Appendix E

Communication Between U.S. Nuclear Waste Technical Review Board and U.S. Department of Energy

ATTACHMENT TO OCTOBER 21, 2003, LETTER FROM THE BOARD TO DR. CHU

CP of Alloy 22 in CaCl₂ Brines (No Nitrate)
(Continued)

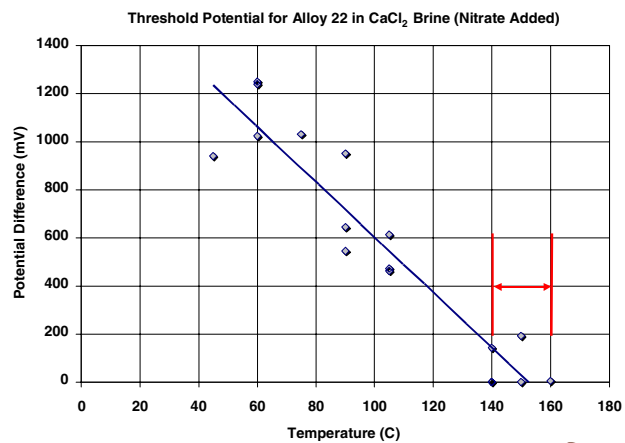
This figure is another overhead from Dr. Farmer’s presentation at the January 28, 2003, Board meeting. (There is an error in the title. Instead of “No Nitrate,” it should read “Nitrate Added.”) Again, localized corrosion is virtually certain to initiate when the Potential Difference falls below 0. For Alloy 22 in a concentrated solution of calcium chloride with nitrate added, the overhead indicates that the Potential Difference is below 0 for temperatures of approximately 150°C and higher.

Critical Temperature for Localized Corrosion in Artificial CaCl₂ Brine with NO₃⁻ Inhibitor

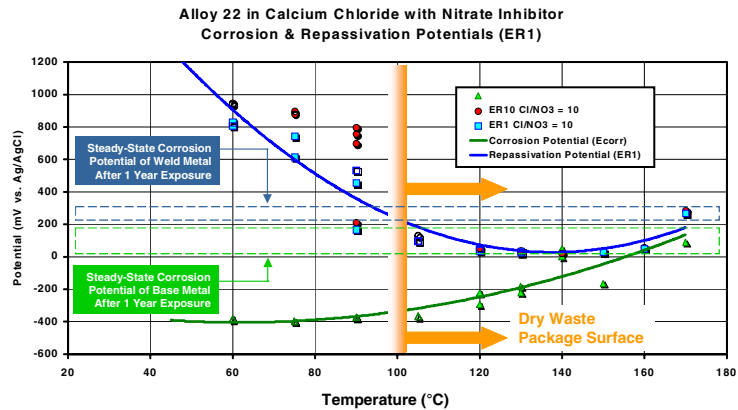
This figure is an overhead from Dr. Farmer's presentation at the May 13, 2003, Board meeting in Washington, D.C. Note the dashed boxes. They indicate that base-metal steady-state corrosion potential moves in a noble (positive) direction with time and that welded-metal corrosion potential moves even farther in that direction with time, indicating increasing susceptibility to crevice corrosion with aging time and in welded structures. Although the overhead appears to state that waste package surfaces are dry above approximately 120°C, deliquescence of salts in the dust on waste package surfaces can cause brines to form at temperatures up to approximately 150°-160°C.

Localized Corrosion of Mill-Annealed Alloy 22

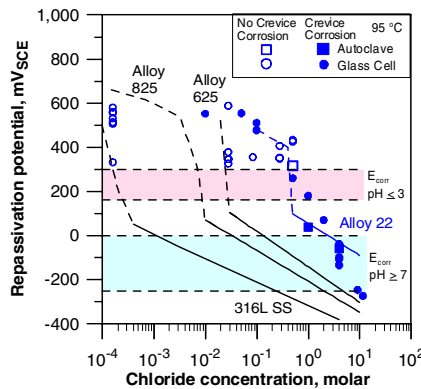
This figure to the right is an overhead from Dr. Cragolino's presentation at the May 14, 2003, Board meeting in Washington, D.C. Note that Alloy 22 is more resistant to localized corrosion than other nickel-chromium-molybdenum alloys (alloys 625 and 825) and than a nickel-chromium alloy (316 stainless steel).

Effect of Fabrication Processes on Localized Corrosion

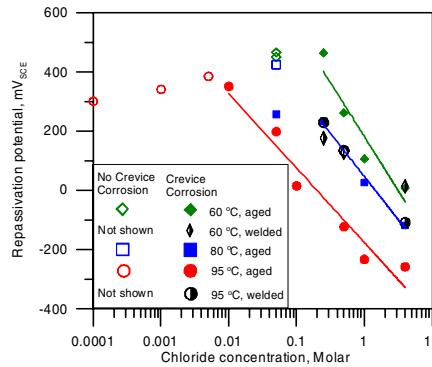
This figure is an overhead from Dr. Cragnolino's presentation at the May 14, 2003, Board meeting. It illustrates the increased susceptibility of welded and thermally aged Alloy 22 in comparison to mill-annealed material.

Effect of Nitrate on Localized Corrosion of Alloy 22

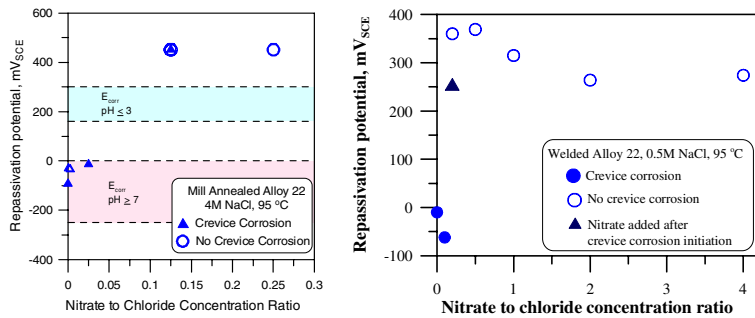
This figure is an overhead from Dr. Cragnolino's presentation at the May 14, 2003, Board meeting. It illustrates the beneficial effect of nitrate on localized corrosion susceptibility of Alloy 22 at 95°C. There is an error in the next-to-last line. Rather than "1.2 for mill-annealed material," it should read "0.12 for mill-annealed material."

Effect of Temperature on Localized Corrosion

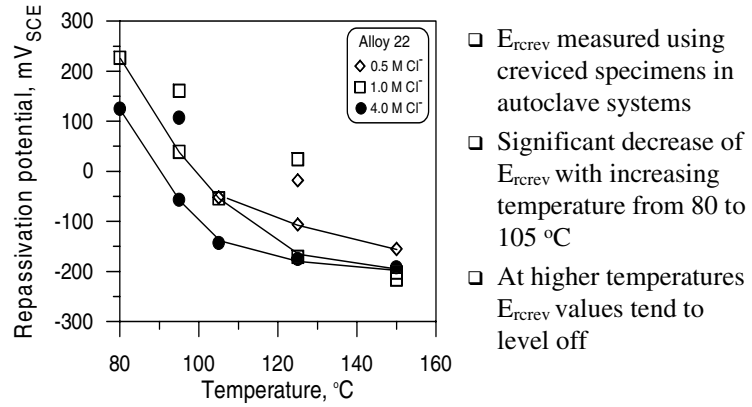
This figure is an overhead from Dr. Cragolino's presentation at the May 14, 2003, Board meeting. It illustrates how repassivation potential decreases with temperature.
